TRANS/WP.29/2005/5
22 December 2004

World Forum for Harmonization of Vehicle Regulations (WP.29)
(One-hundred-and-thirty-fifth session, 8-11 March 2005,
agenda item 4.2.18.)

PROPOSAL FOR SUPPLEMENT 3 TO REGULATION No. 109
(Retreaded pneumatic tyres for commercial vehicles)

Transmitted by the Working Party on Brakes and Running Gear (GRRF)

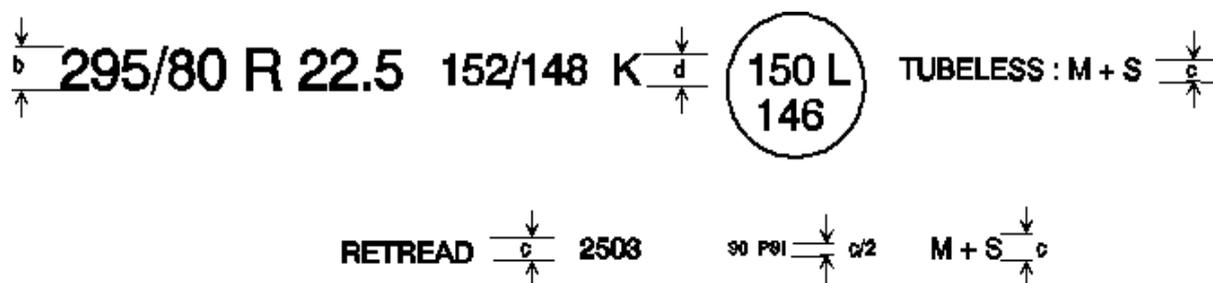
Paragraph 7.1.5.1.2., amend to read:

"7.1.5.1.2 For sizes referred to in paragraph 7.1.2.2. and for tyres identified by the tyre to rim fitment configuration symbol "A" (see paragraph 2.21.4.), the nominal section height "H" is equal to:

$$H = 0.5(D - d)$$

where "D" and "d" are as defined in paragraph 7.1.2.1."
